Device	XMC1400
Marking/Step	EES-AA, ES-AA, AA
Package	PG-VQFN-40/48/64, PG-LQFP-64, PG-TSSOP-38

Overview

This “Errata Sheet” describes product deviations with respect to the user documentation listed below.

Figure 1 CCU8 simplifier PWM generation scheme - a) normal mode; b) asymmetric mode

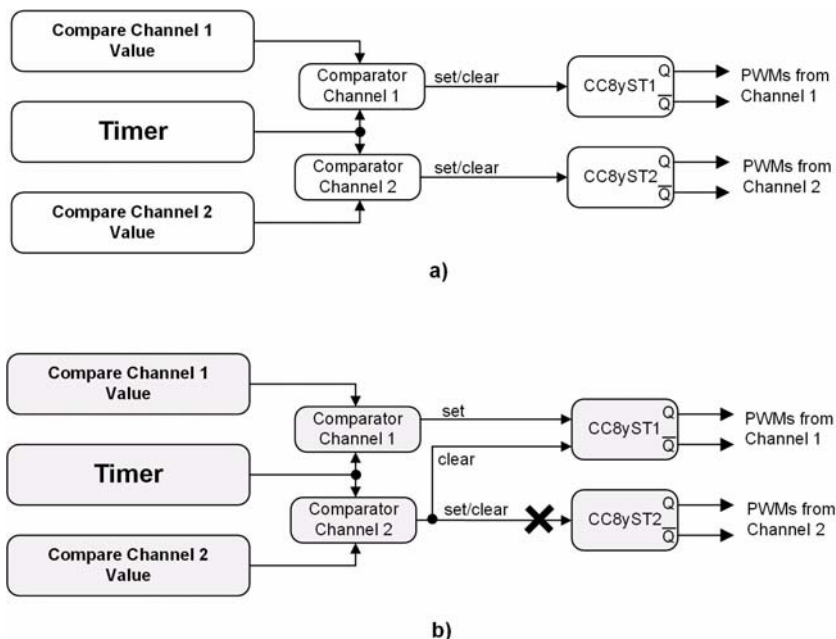
The asymmetric mode has a bug, where the PWM signal of Compare Channel 2 is not stored in CC8yST2. This means that from the Compare Channel 2 the timer cannot generate any PWM signal - depicted by the cross on **Figure 1 b)**.

None

Figure 2 CCU8x concatenation feature resource configuration - a) without external count function; b) with external count function

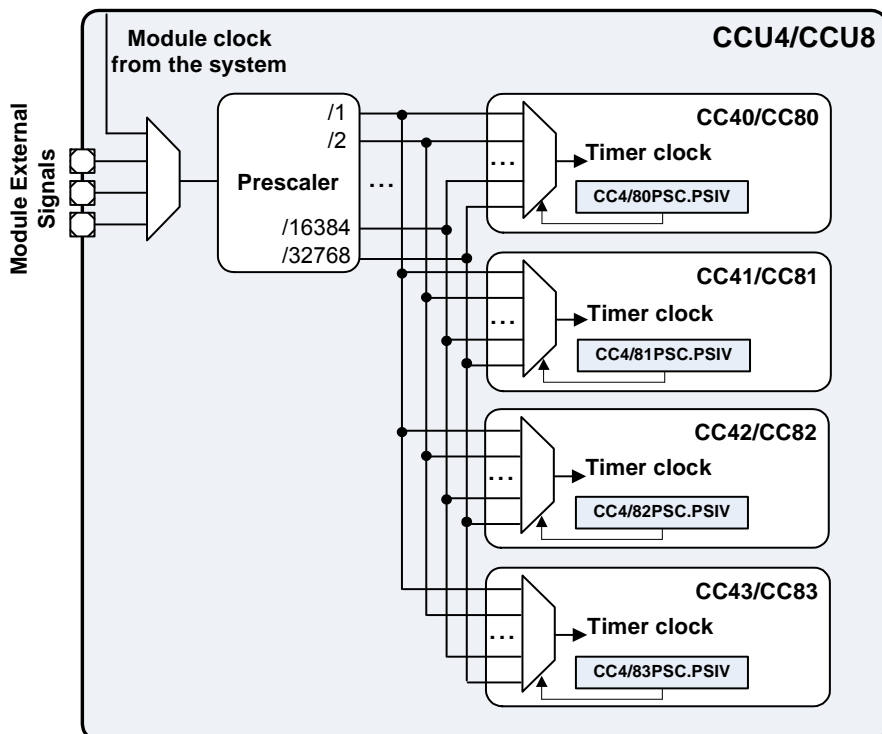
When an external count signal is enabled - by programming the CC8yCMC.CNTS with 01_B, 10_B or 11_B - the concatenation function does not work. One cannot use in parallel the timer concatenation and external count signal features.

Note: On Figure 1, the count signal is used in CCU80 because this timer represents the LSBs. While the count signal could be enabled in the MSB timer (CC81), this does not make sense when the timers are concatenate - because the count should be used to increment the LSB timer. The LSB timer will then in each wrap around, increment the MSB timer.

None

Figure 3 Alert Interrupt Behavior in case of Bus-Off

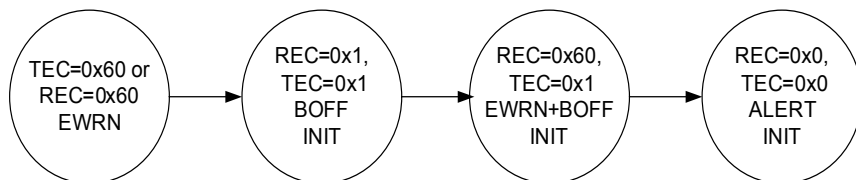
When the threshold for error warning (EWRN) is reached (default value of Error Warning Level EWRN = 0x60), then the EWRN interrupt is issued. The bus-off (BOFF) status is reached if TEC > 255 according to CAN specification, changing the MultiCAN module with REC and TEC to the same value 0x1, setting the INIT bit to 1_B, and issuing the BOFF interrupt. The bus-off recovery phase starts automatically. Every time an idle time is seen, REC is incremented. If REC = 0x60, a combined status EWRN+BOFF is reached. The corresponding interrupt can also be seen as a pre-warning interrupt, that the bus-off recovery phase will be finished soon. When the bus-off recovery phase has finished (128 times idle time have been seen on the bus), EWRN and BOFF are cleared, the ALERT interrupt bit is set and the INIT bit is still set.

Figure 4 Loss of Arbitration

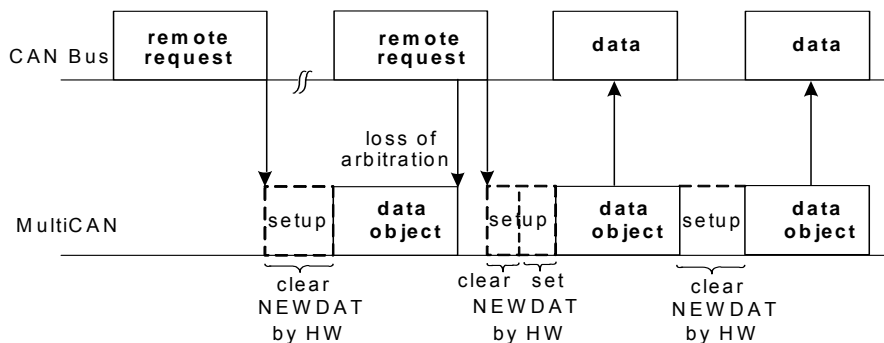
Assume the following scenario: A first remote frame (dedicated to a message object) has been received. It performs a transmit setup (TXRQ is set) with clearing NEWDAT. MultiCAN starts to send the receiver message object (data frame), but loses arbitration against a second remote request received by the same message object as the first one (NEWDAT will be set).

When the appropriate message object (data frame) triggered by the first remote frame wins the arbitration, it will be sent out and NEWDAT is not reset. This leads to an additional data frame, that will be sent by this message object (clearing NEWDAT).

There will, however, not be more data frames than there are corresponding remote requests.
